2 H@NC - 40 Eagle Crest Court, Lillington, NC 27546

# PLAN 1 The Clayton - LH

10-15-24 - Redlines -JJ

THE CLAYTON - LH  
Cover Sheet 'Low Country'

WITH SECOND FLOOR AND OPT. OWNER'S SUITE WITH LARGE WALK-IN CLOSET  
 SLAB FOUNDATION 'LOW COUNTRY'  
 SCALE: 1/8"=1'-0" ON 11x17, 1/4"=1'-0" ON 22x34

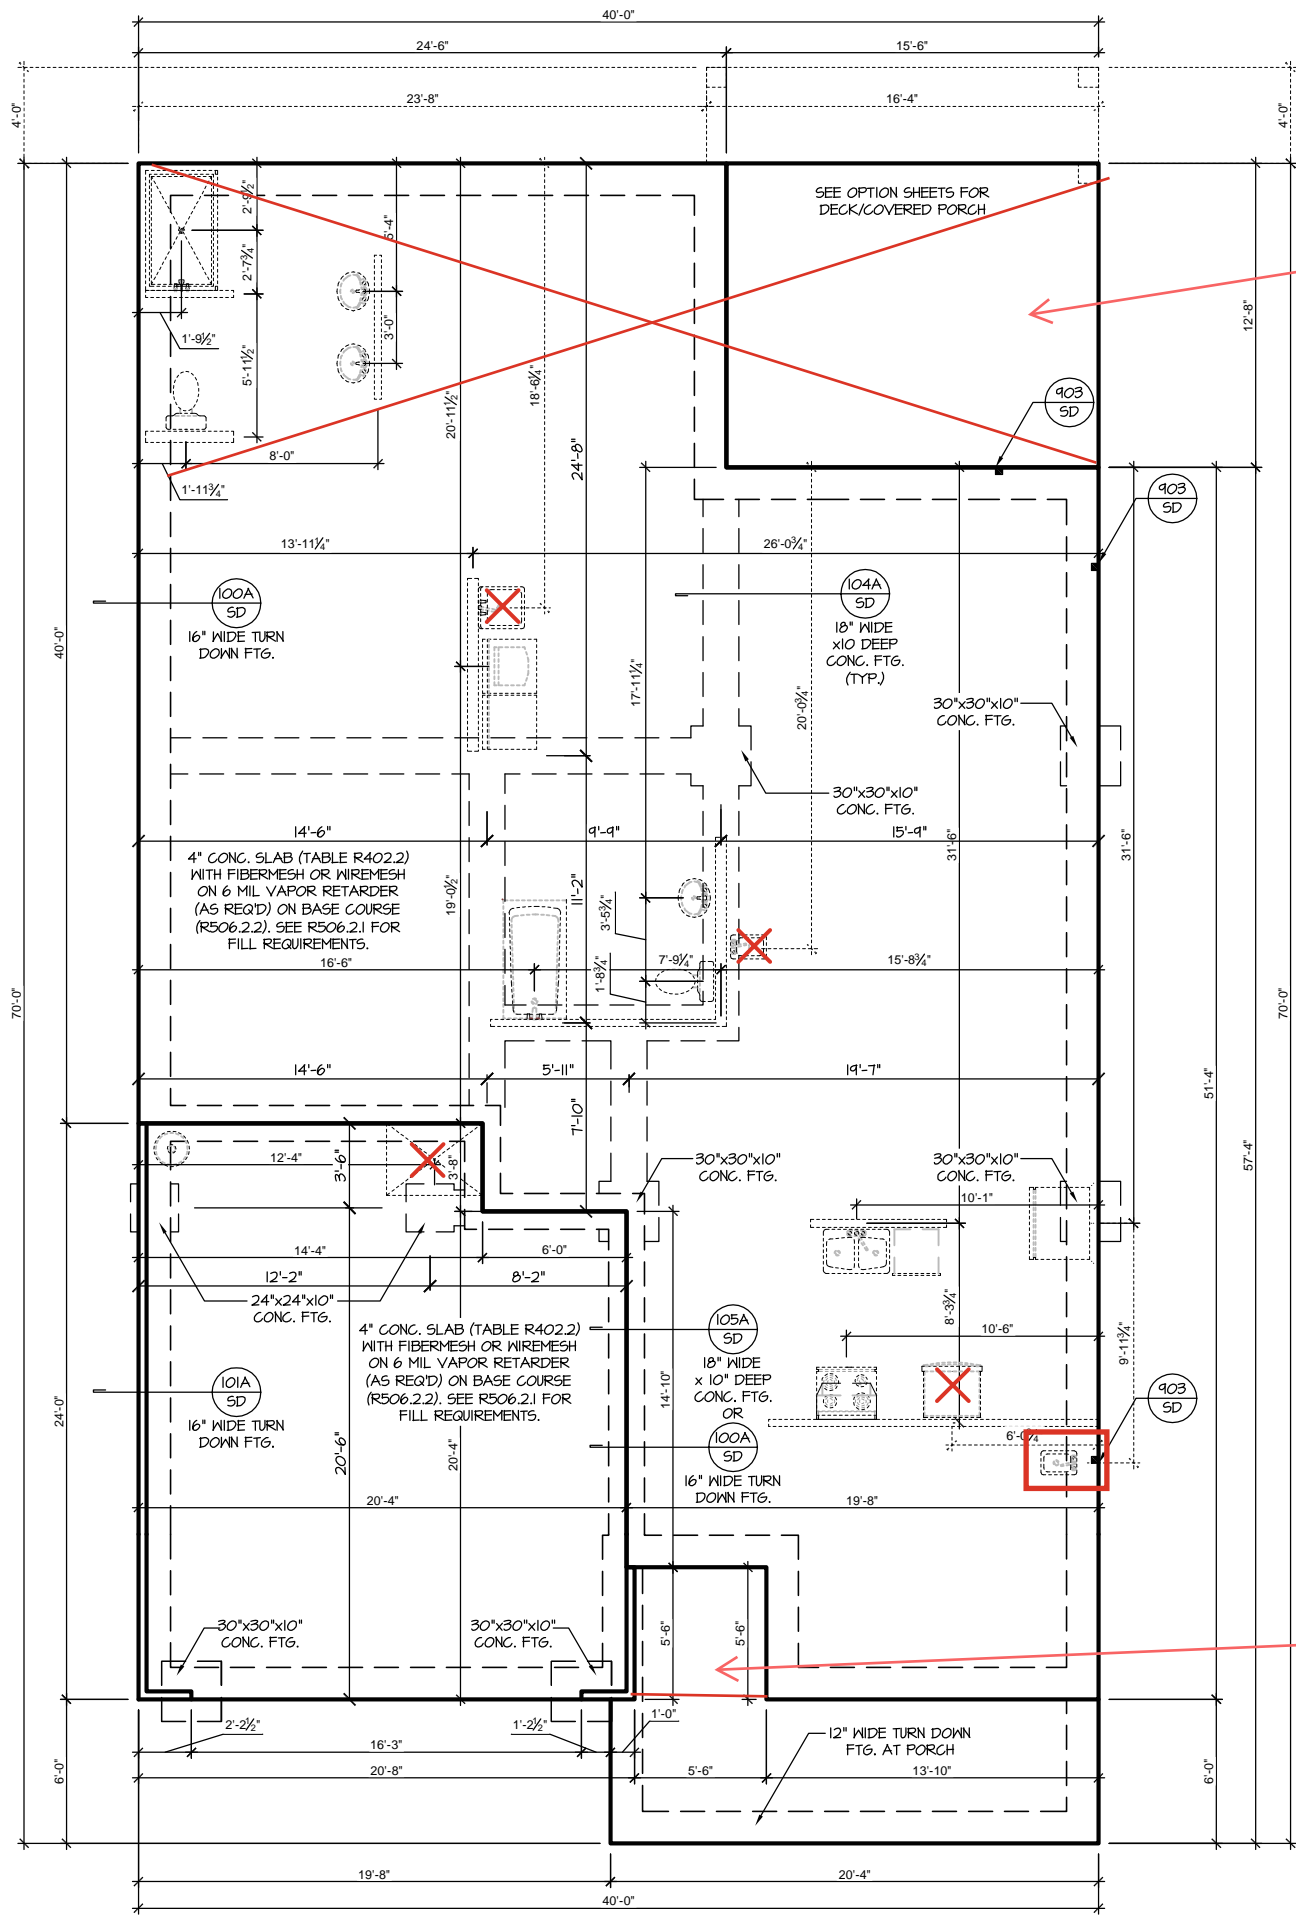
S-1.1.1 - covered porch w/ family room fireplace foundation

S-1.1.1 for smart door delivery fnd

S-2.1

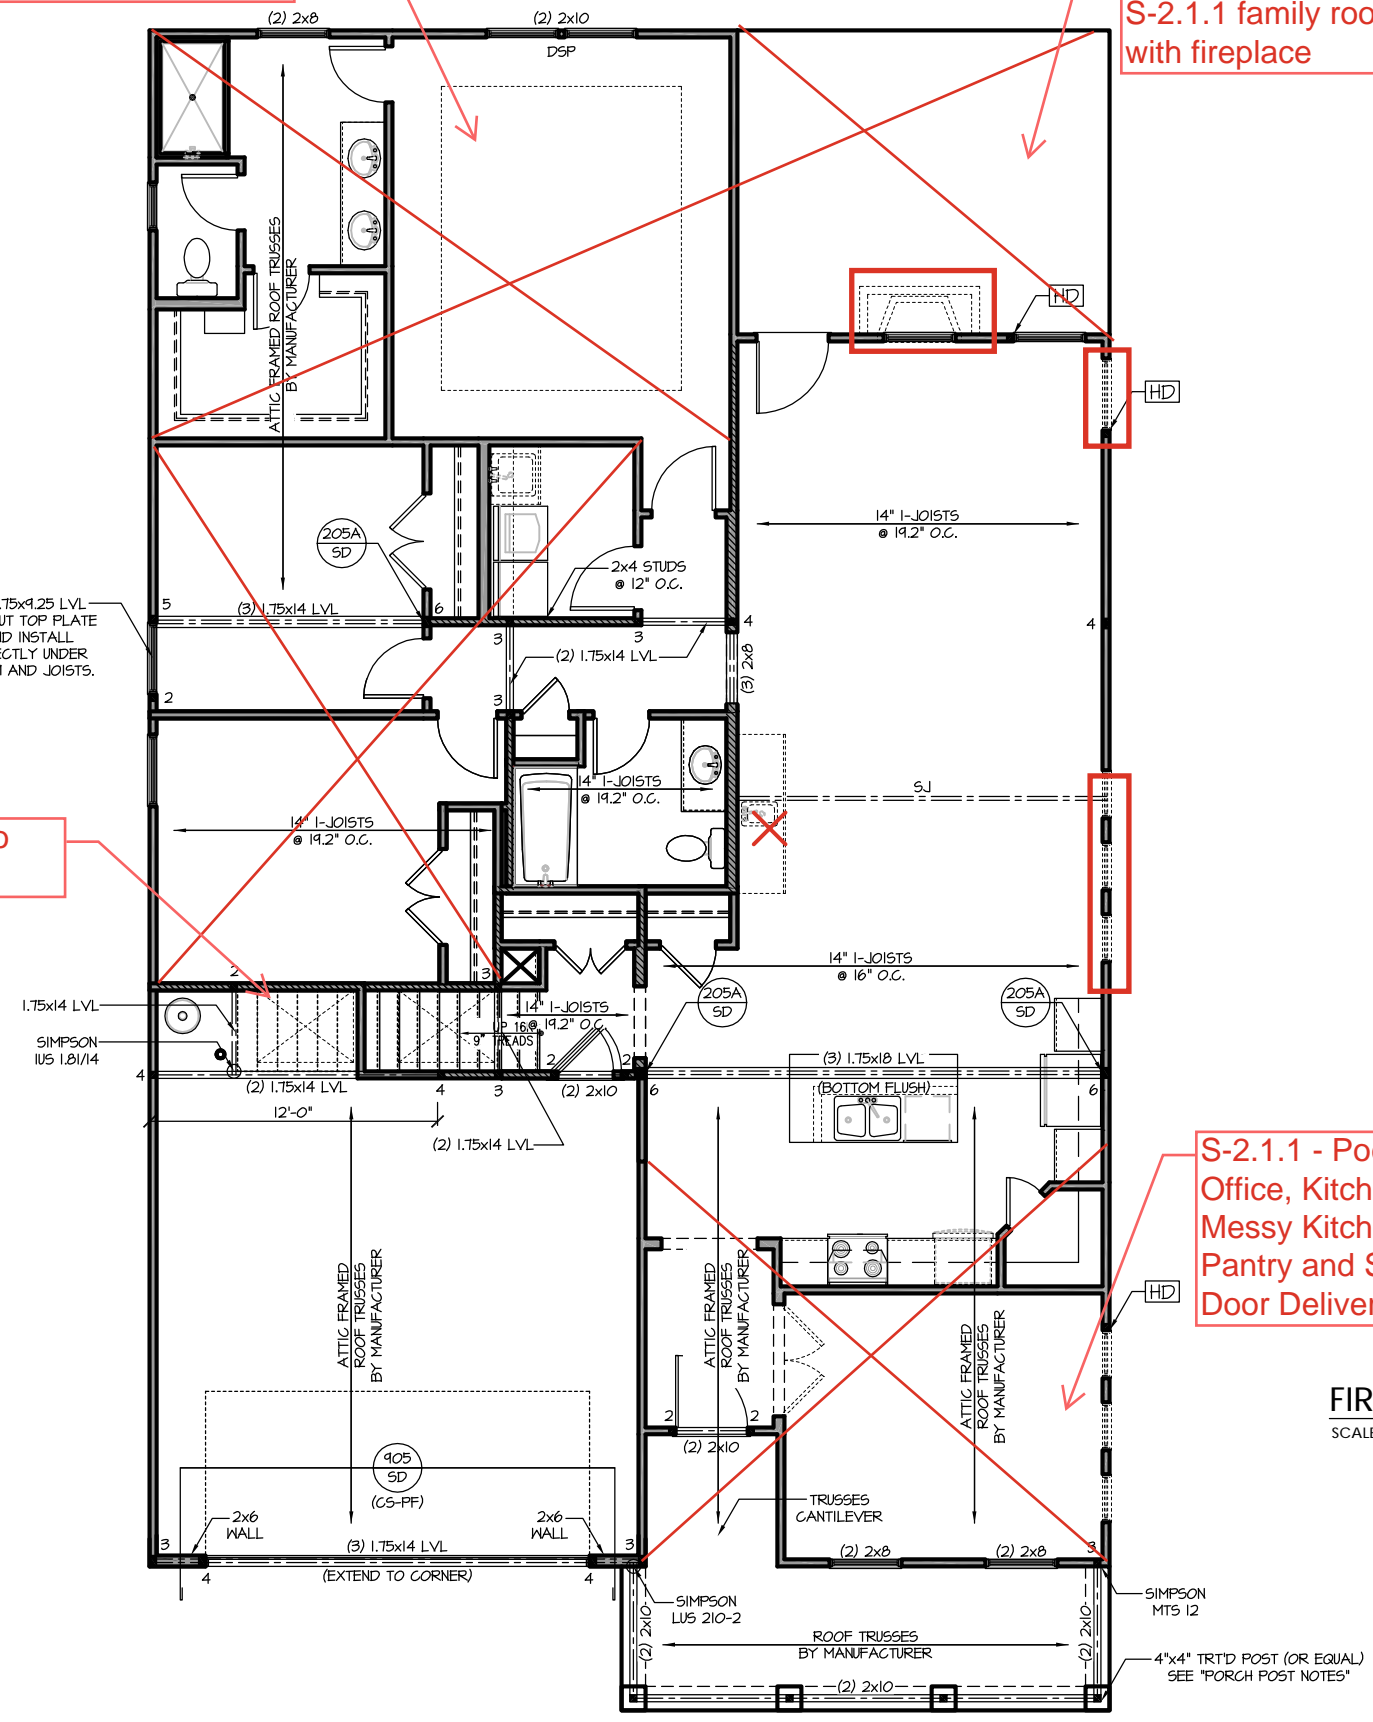
S-2.1.2 for owner's suite with large walk in closet and tub and shower with seat in bath and Bedroom2
